ADDENDUM No. 6

PROJECT: I-85 North Bridge
 Project No.: 512-15-003
 Bid Number: HC2020-2040

The following items are being issued herein for modification and clarification to the Bid Requirements for the project referenced above. All Bidders shall acknowledge this Addendum within their submittal.

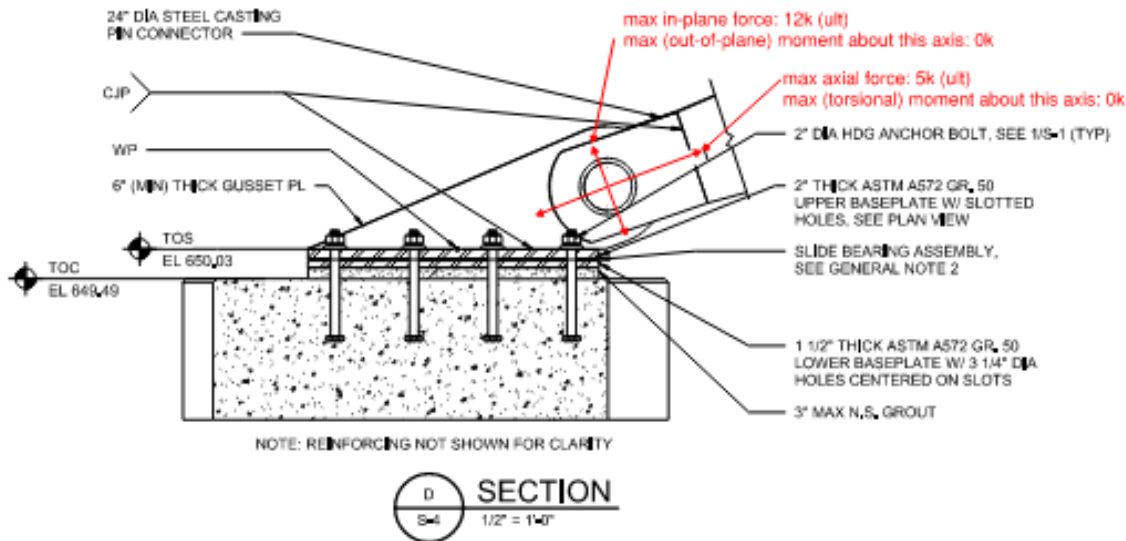
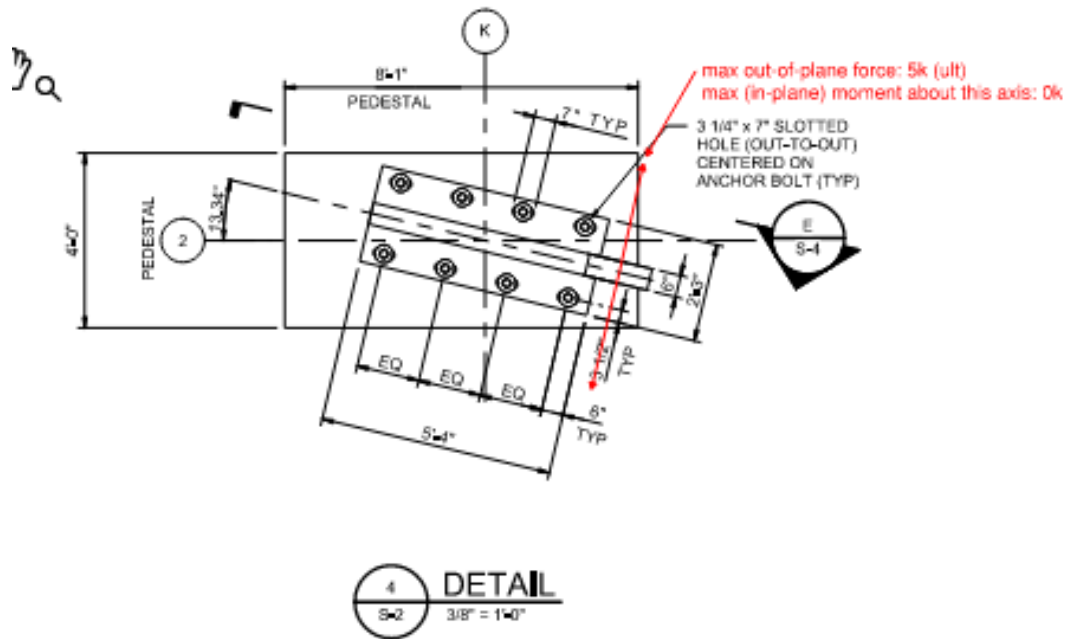
17. Regarding the Bridge Truss for the I-85 North Bridge Project, can you please provide additional details for the 24" Steel Casting Pin Connectors, such as pin diameter and material type?

Answer: The 24" Steel Casting Pin Connectors are to be designed by the casting supplier. The supplier would supply both the casting and the pin. See sketch for loads:

We would anticipate the connector would be ASTM A958, Grade SC8620, Class 80/50:

- Minimum yield strength: $F_y = 50 \text{ ksi}$
- Minimum tensile strength: $F_u = 80 \text{ ksi}$

We would anticipate the pin would be ASTM A322, Grade 4140:

- Minimum yield strength: $F_y = 42 \text{ ksi}$
- Minimum tensile strength: $F_u = 75 \text{ ksi}$
- We would anticipate the pin to be on the order of 8.5" in diameter
